Good afternoon Commissioners and Staff, My name is Shad Stevens

I would like to address several issues with Geronimo's new permit application. This application is primarily a cut and paste of the previous application and most of the issues are not new:

Table 1: Summary of Tower Structures

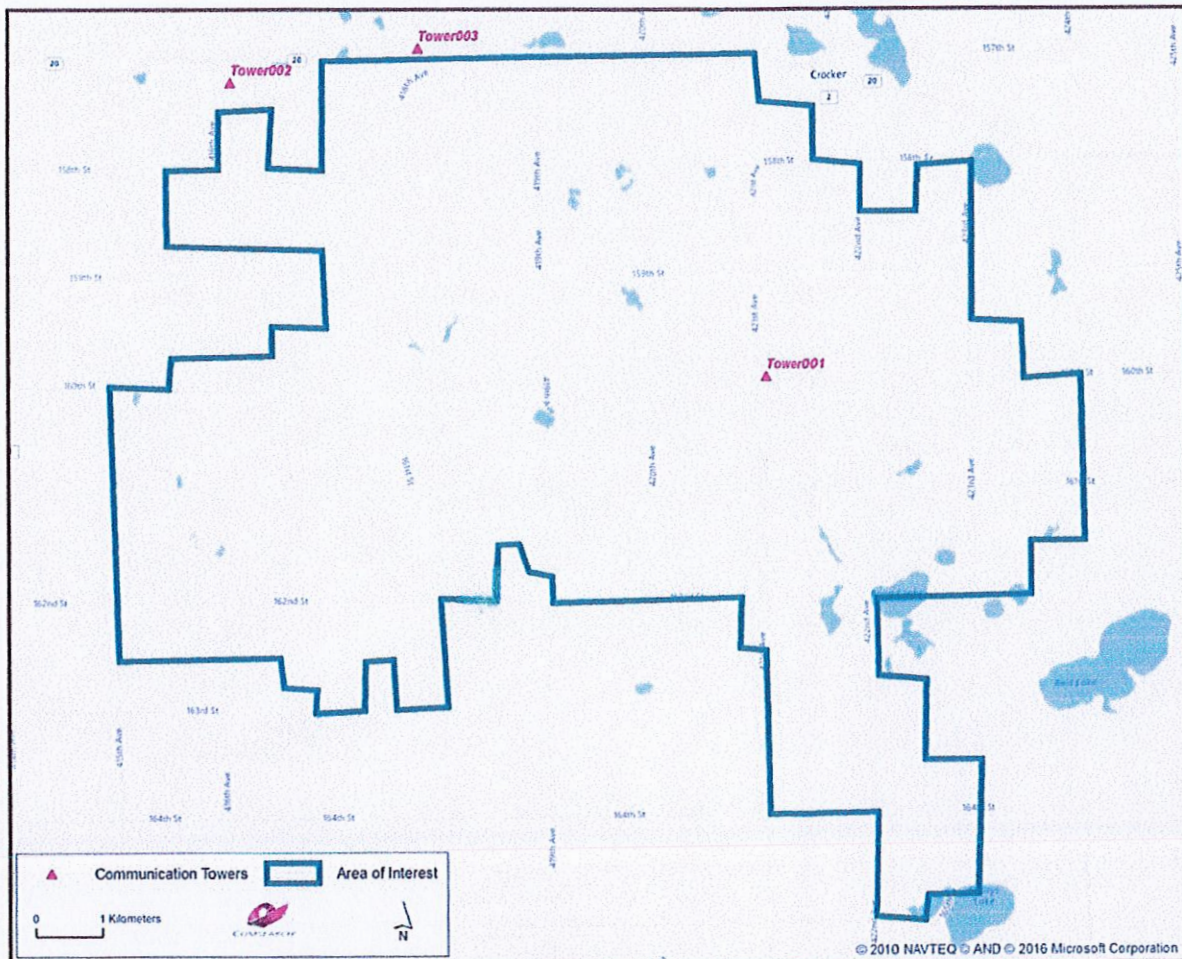
Study results are frequently misrepresented by Geronimo. Page 135 of the Application (attached) indicates FCC approval and permit as "complete". The Comsearch study (Appendix G, page 4) contradicts this. It states: "Our study identified three tower structures and seven communication antennas within or near the project area. They are used for microwave, TV and land mobile services in the area. Detailed impact assessments should be performed for each service type". Page 5 of the Microwave Study states: "For this project, turbine locations were not provided; thus we could not determine if any potential obstructions exist between the planned wind turbines and the incumbent microwave paths. If the latitude and longitude values for turbine locations are provided, Comsearch can identify where a potential conflict might exist".

The County's CUP included a requirement for a 3<sup>rd</sup> party telecommunications study indicating any disruptive electromagnetic interference would be unlikely. How can the applicant claim compliance with that condition? And what about the validity of the FCC permit?

**Figure 5  
Project Setbacks**  
**Crocker Wind Farm  
Clark County, SD**  
45.079602, -97.845696

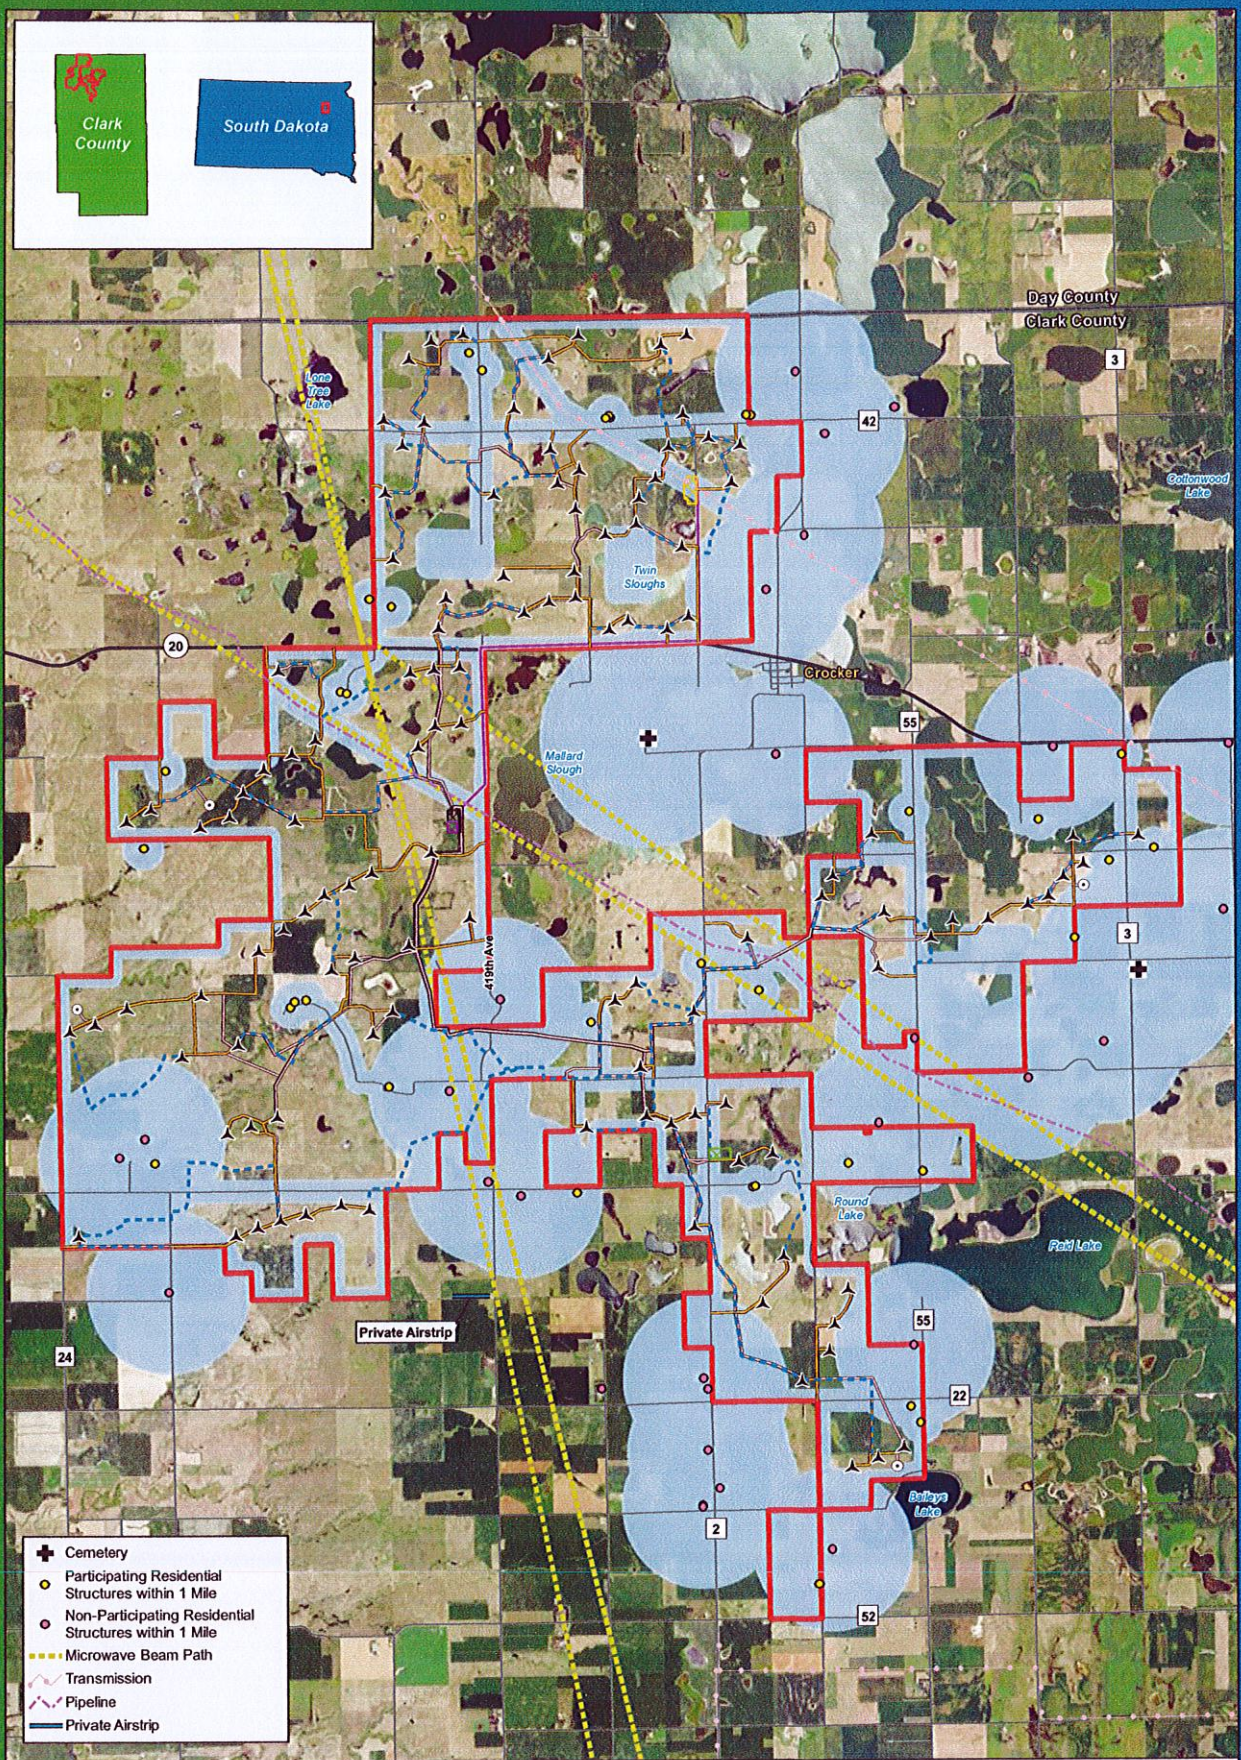
There is no evidence in the permit application of written correspondence with Northern Border Pipeline or Clark Rural Water. We can expect a serious issue with multiple crane path crossings of the gas pipeline during construction. The lower right insert on Figure 13, Land Use asserts that there is no irrigated land or organized water system within the project area. Not true! There is irrigated land in Woodland Township and Clark Rural Water serves farms within the project footprint.
